**AMENDMENTS TO THE DRAWINGS**

Application Serial No.: 09/450,802  
Title: Method And System For Source Synchronous Clocking  
**REPLACEMENT SHEET**

FIGURE 1

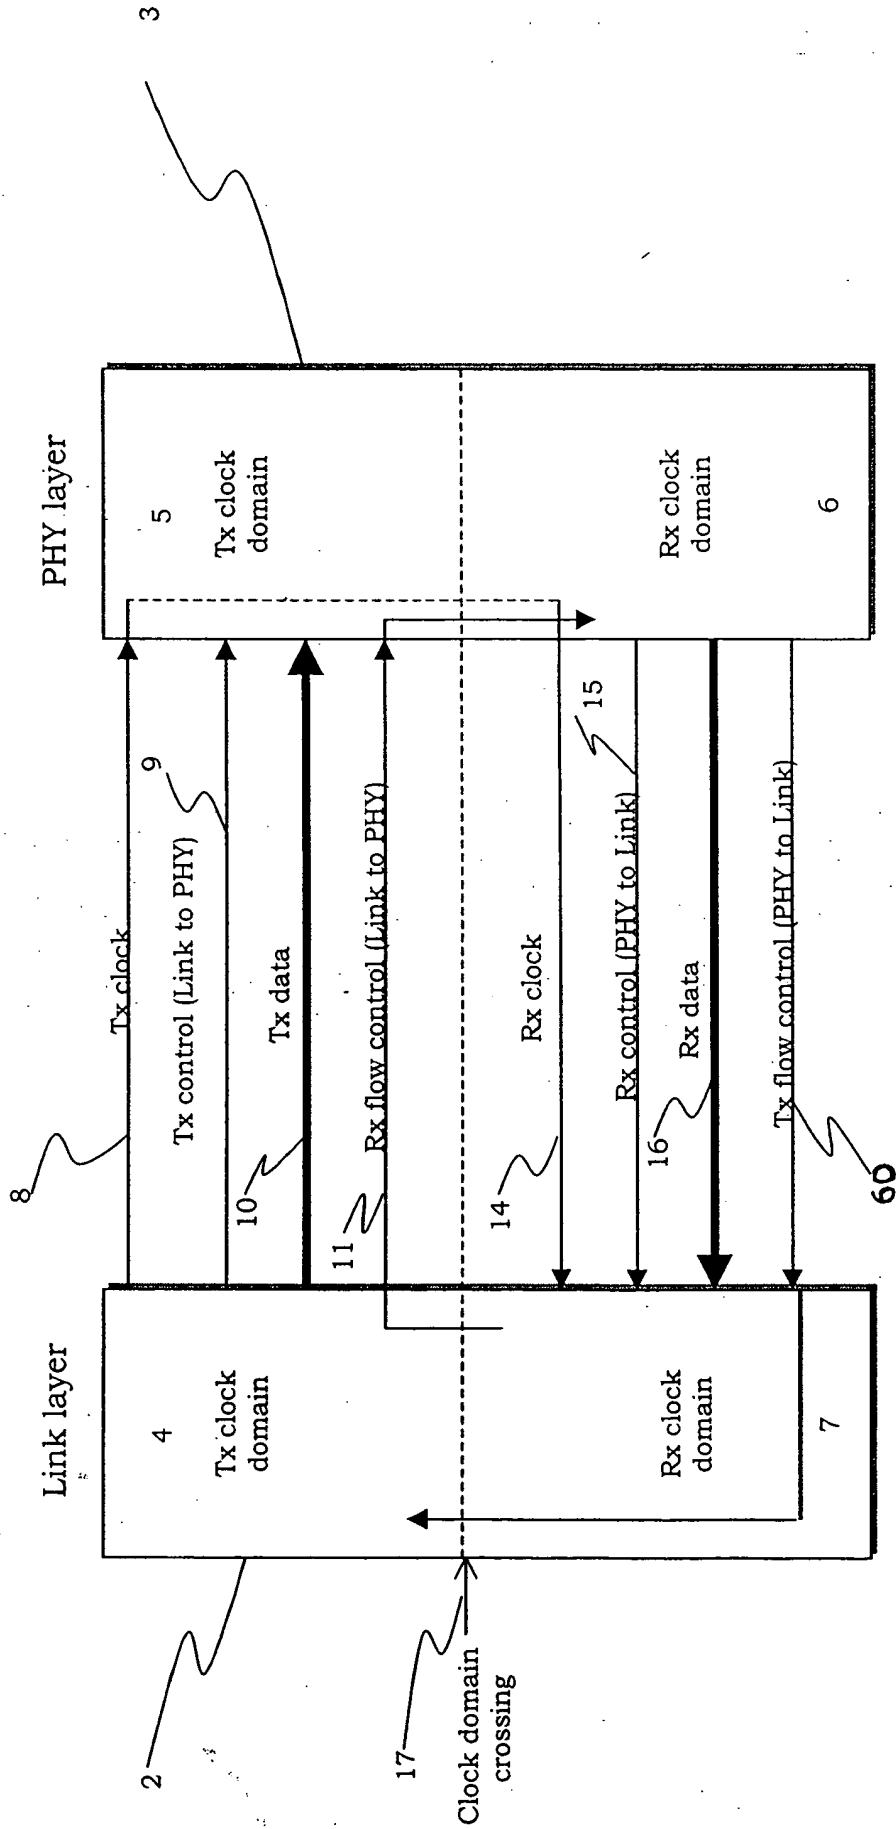
The attached sheets of drawings include changes to Figs. 1 and 2. These sheets replace the original sheets including Figs. 1 and 2. Figs. 1 and 2 have been amended to conform more clearly with the corresponding detailed description. In particular, Fig. 1 has been amended to remove reference numeral 13 (which does not appear in the corresponding detailed description) and to replace reference numeral 17, used to describe the TX flow control signal, with reference numeral 60. The detailed description has been amended to reflect the use of reference numeral 60. Fig. 2 has been amended to remove reference numeral 12, which does not appear in the corresponding detailed description.
